**Pacific Gas and
Electric Company®**

PG&E Letter DCL-15-026

Docket No. 50-275, OL-DPR-80
Docket No. 50-323, OL-DPR-82
Diablo Canyon Units 1 and 2
Pacific Gas and Electric Company's Fourth Six-Month Status Report in Response to
March 12, 2012, Commission Order Modifying Licenses with Regard to
Requirements for Mitigation Strategies for Beyond-Design-Basis External Events
(Order Number EA-12-049)

**Pacific Gas and Electric Company's Fourth Six-Month Status Report for the
Implementation of NRC Order EA-12-049**

Figure 1
 Staging Routes
 Primary BDB Storage Facility

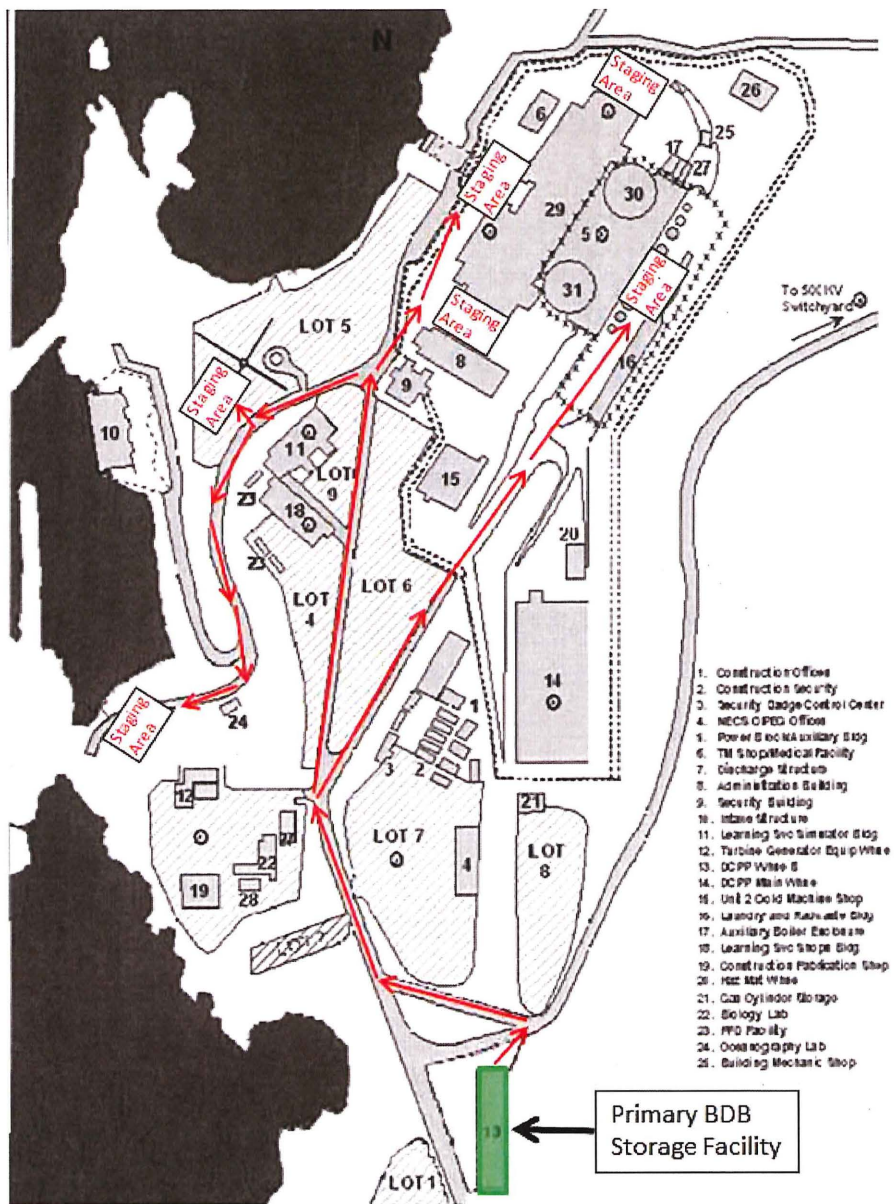
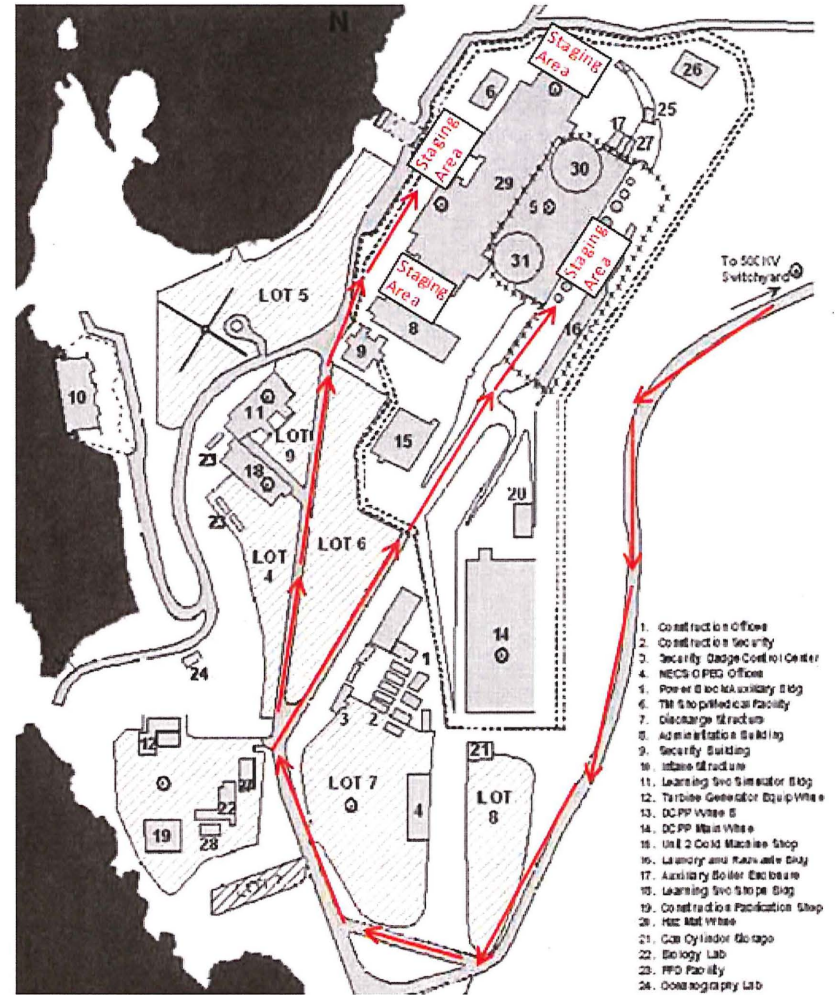
- (1) Figure 1 Revisions:
 - (a) Figure retitled to “Staging Routes Primary BDB Storage Facility”
 - (b) Routes revised to reflect deployment routes as evaluated in design change
 - (c) Addition of staging areas and deployment routes for the 4 kV generators
- (2) Figure 2 Revisions:
 - (a) Figure retitled to “Staging Routes Secondary BDB Storage Facility”

Figure 2
 Staging Routes
 Secondary BDB Storage Facility

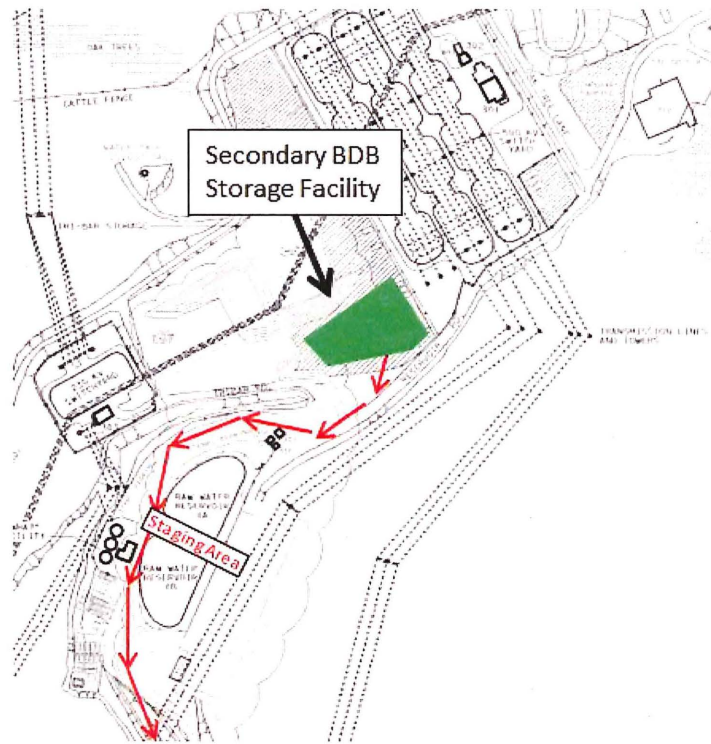
- (b) Routes revised to reflect deployment routes as evaluated in design change
- (3) Figure 5A was revised to show the staging location of the raw water reservoir (RWR) pump as being located between the reservoirs, as this location was changed during the design change process.

Figure 6A
 All Strategies – Primary
 Unit 1 and 2
 Elevation 115'

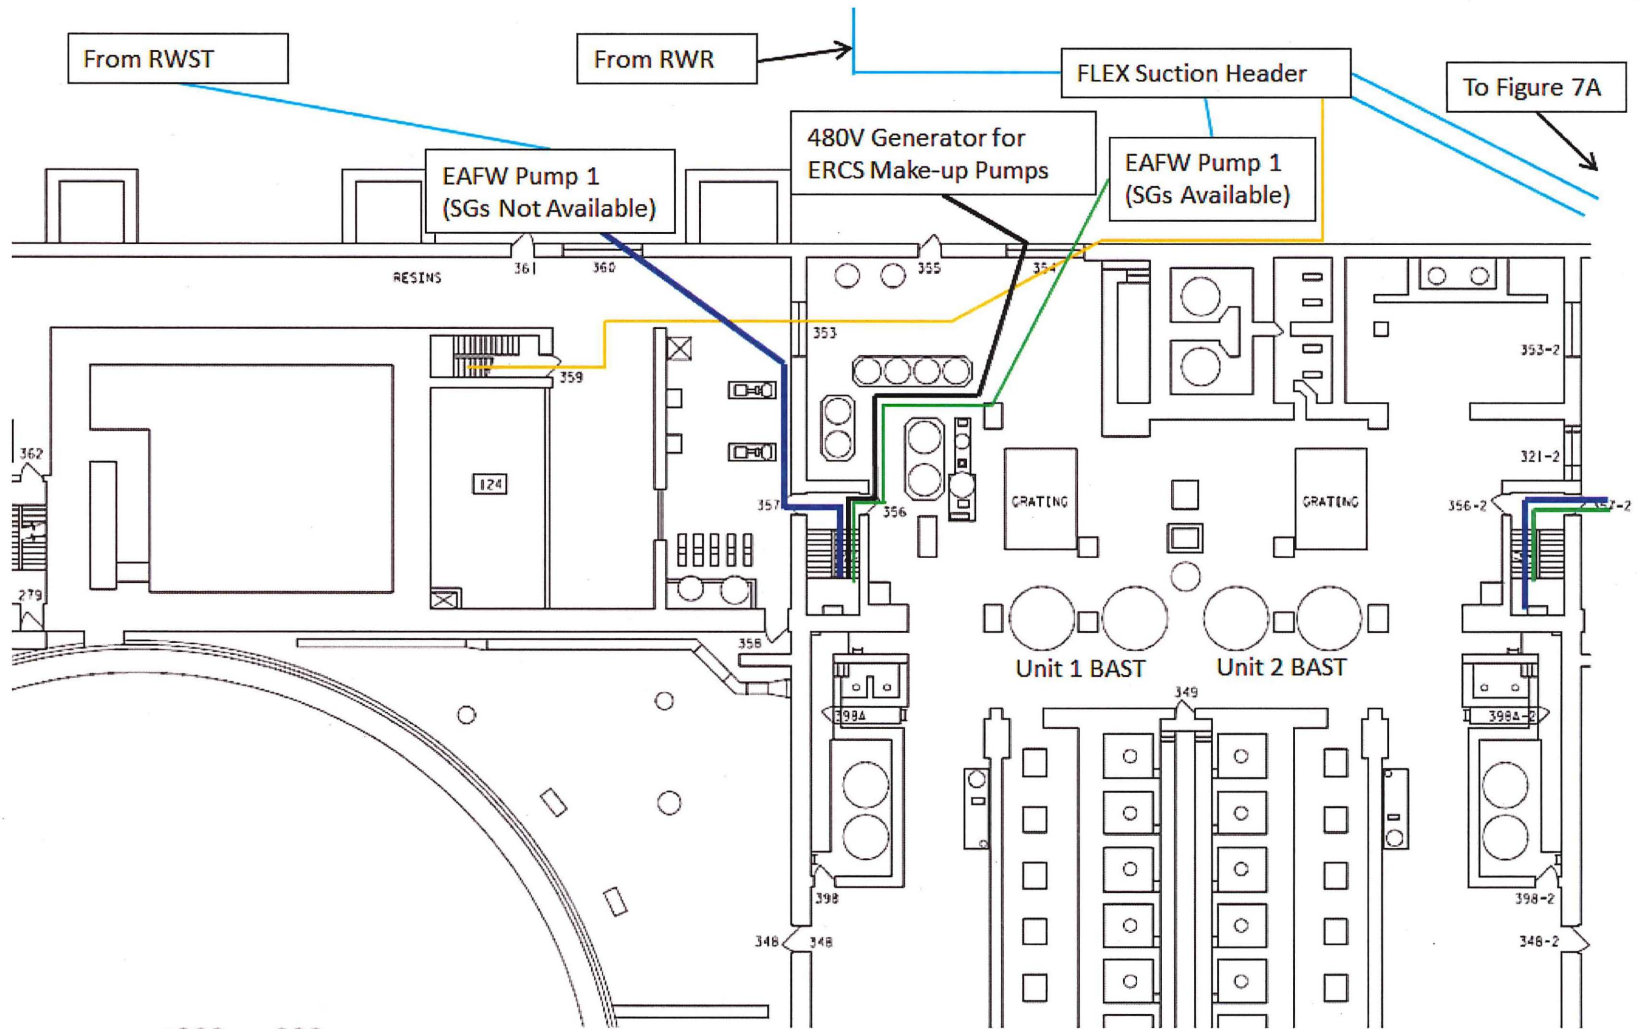
- (4) Figure 6A was revised to show the staging location and hose routes for the Unit 1 emergency auxiliary feed water (EAFW) pumps for steam generators not available through roll-up door 360. This reflects the deployment for the Unit 2 EAFW pumps for steam generators not available.

Figure 7B
 All Strategies – Primary
 Unit 2
 Elevation 100'

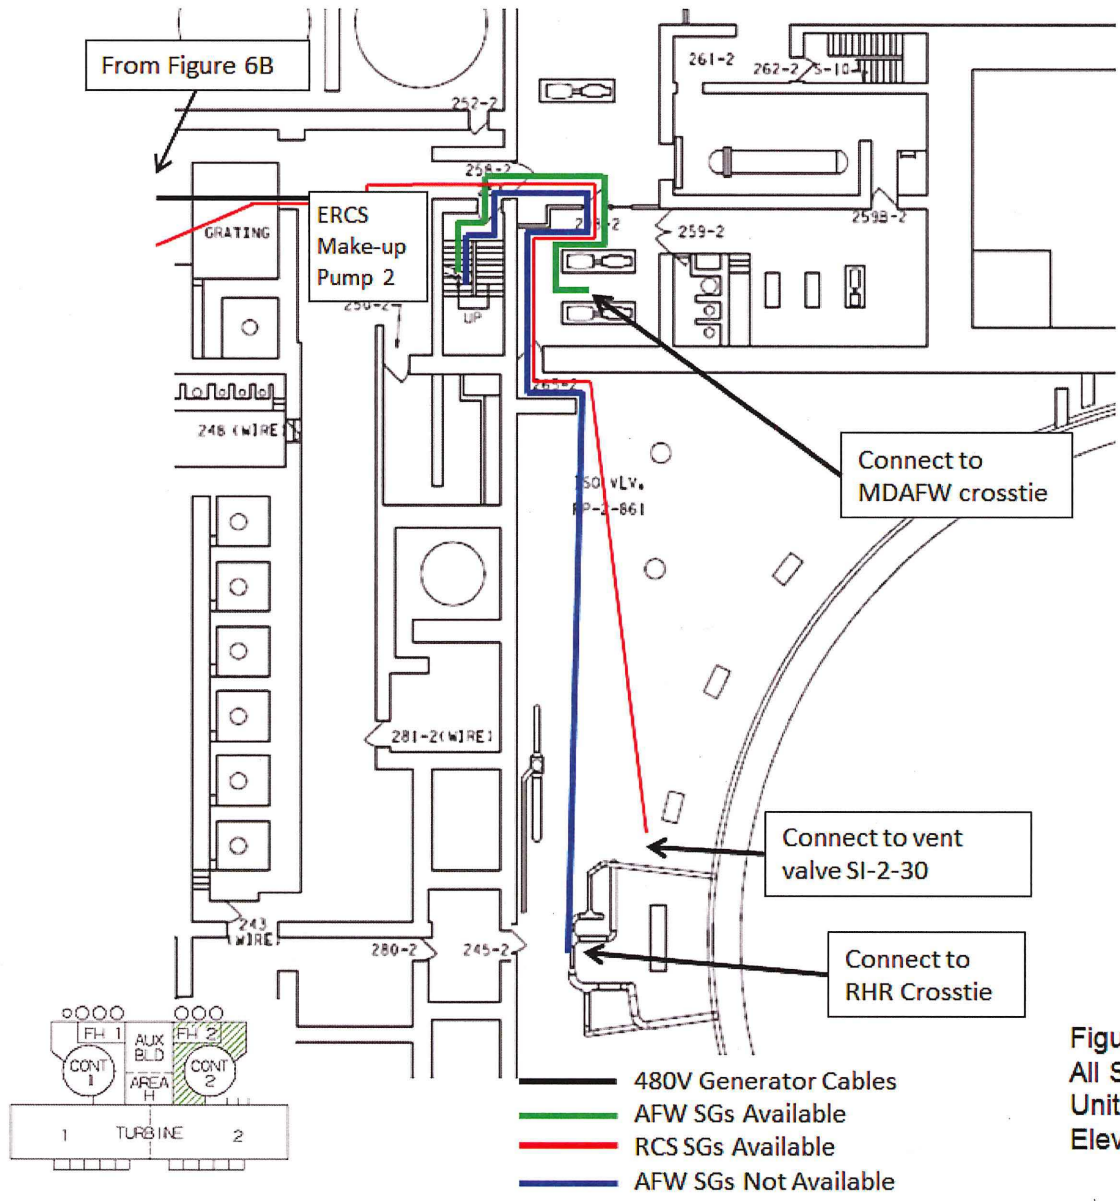
- (5) Figure 7B was revised to clarify hose routes to pass through door 298-2.
- (6) Figure 8C was revised to clarify deployment hose route for the Unit 1 EAFW pump.

Figure 20E
480-Vac Cable Routing
Elevation 128'

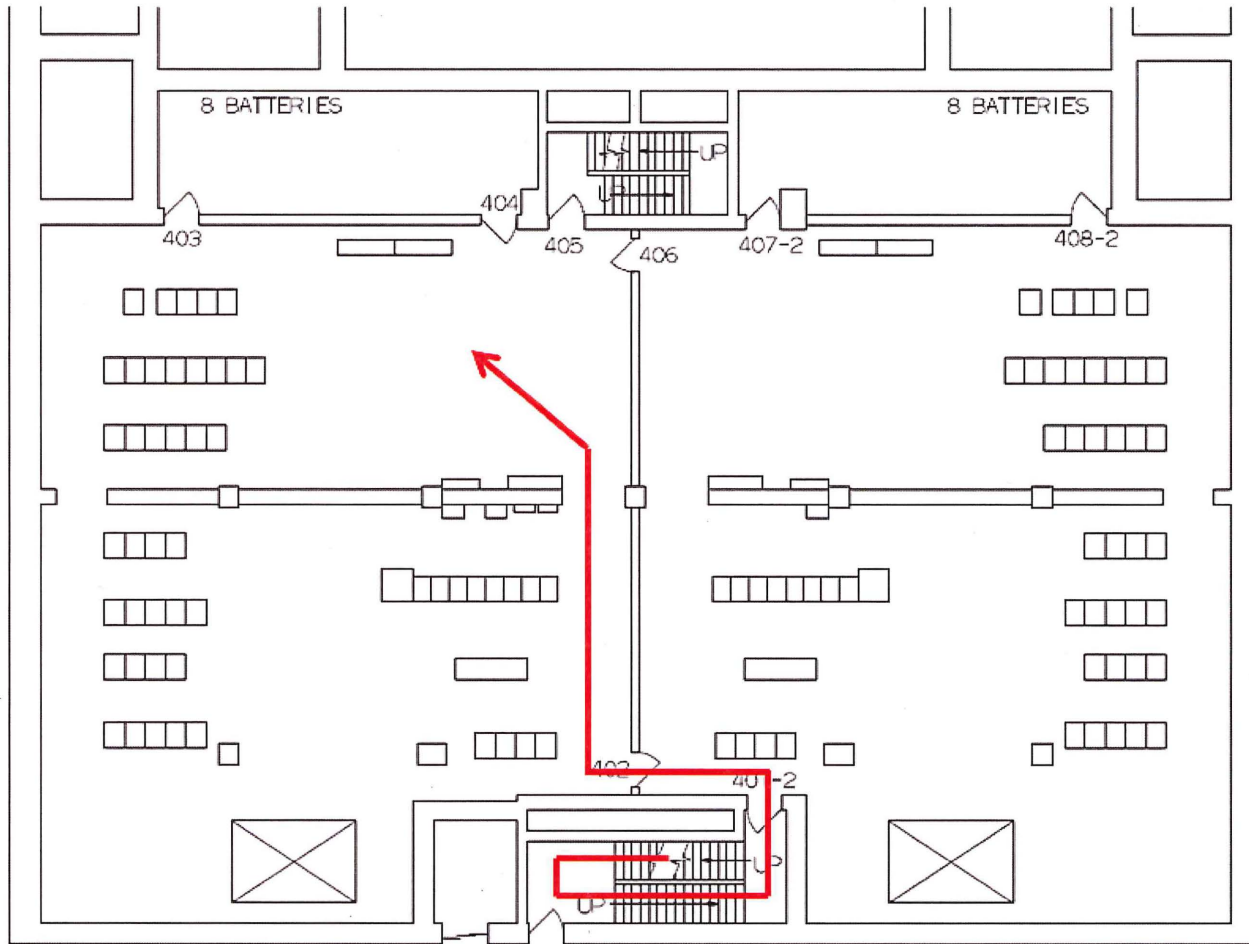
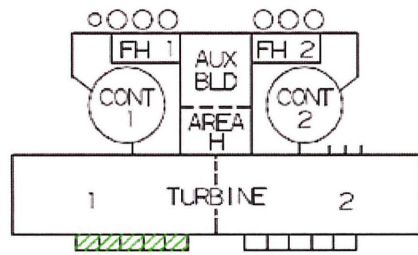
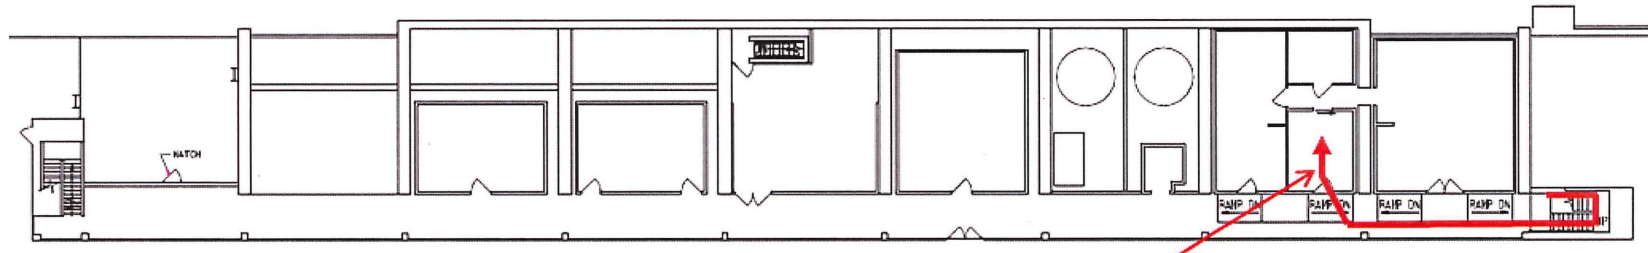
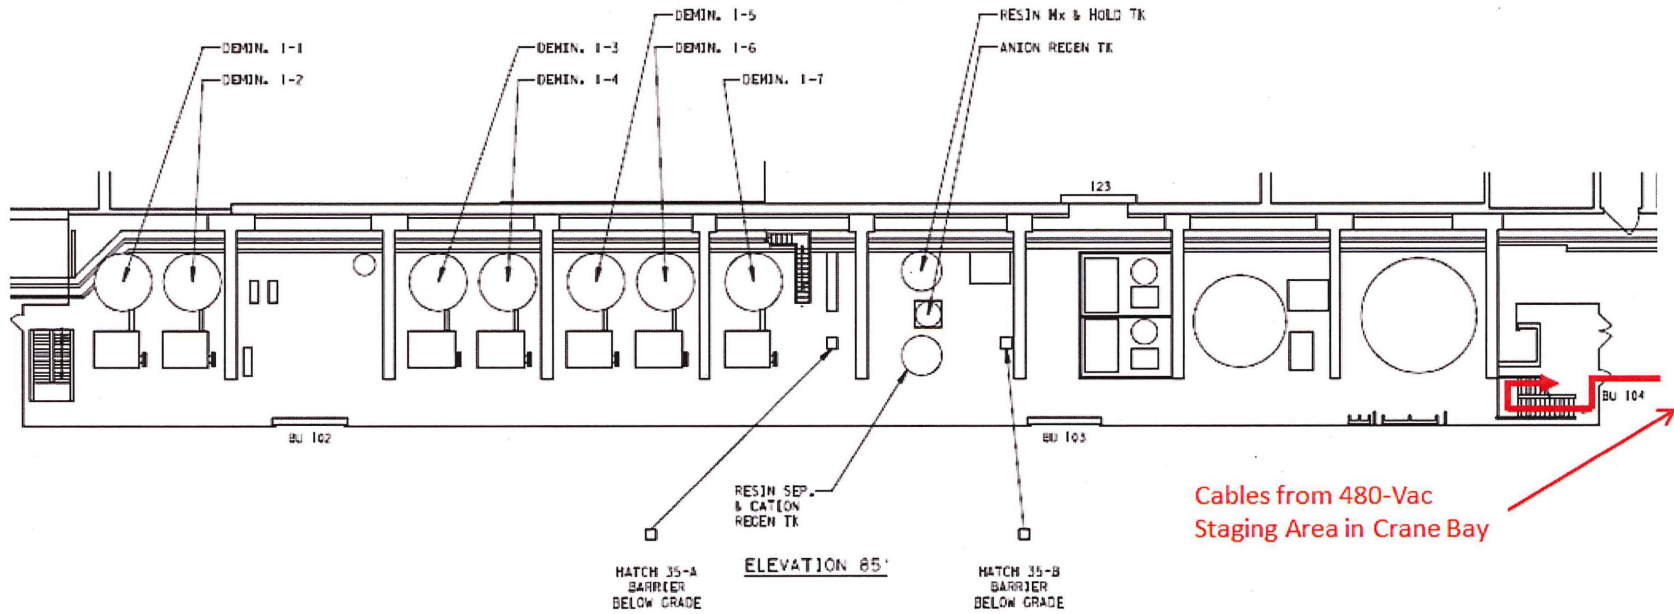
- (7) Figure 20A, "480-Vac Staging and Cable Deployment, Elevation 85'," was revised to reflect the evaluated deployment route.
- (8) Figure 20E, "480-Vac Cable Routing, Elevation 128'," was created to show the 480-Vac cable routing on the 128 foot elevation of the auxiliary building.

Figure 20G
 480-Vac Cable Routing
 Elevation 104', Unit 2

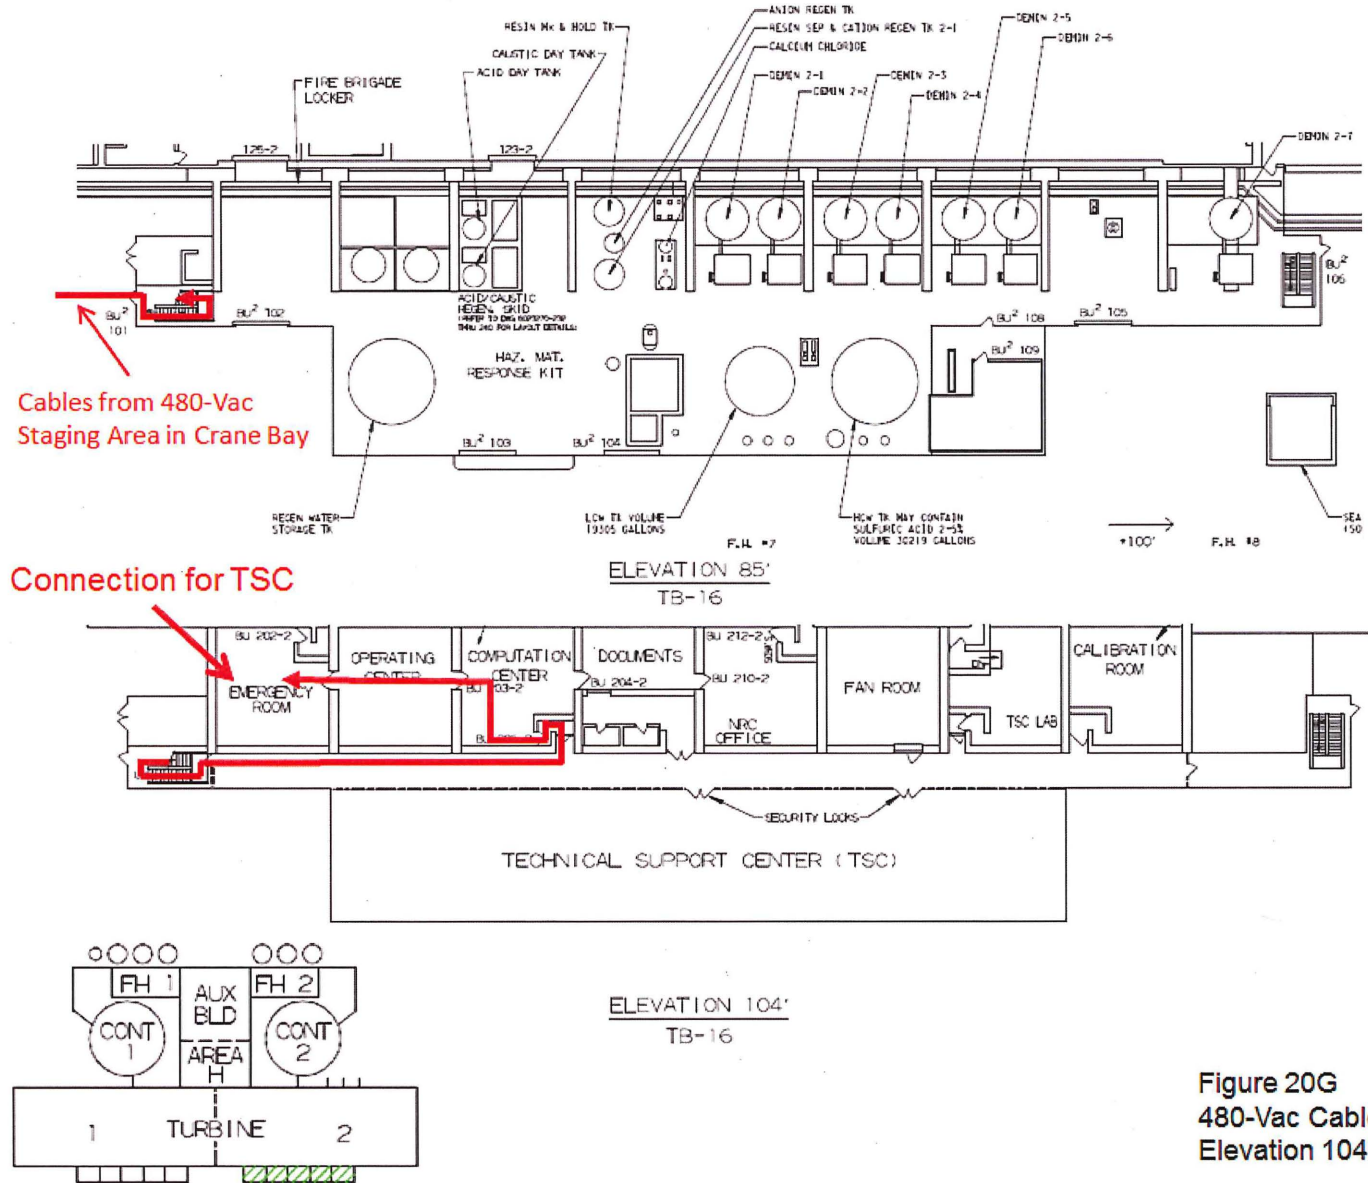
- (10) Figure 20G, "480-Vac Cable Routing, Elevation 104', Unit 2" was created to show the 480-Vac cable routing to the TSC to repower satellite and radio communications equipment on the 104' elevation of the Unit 2 buttress building.
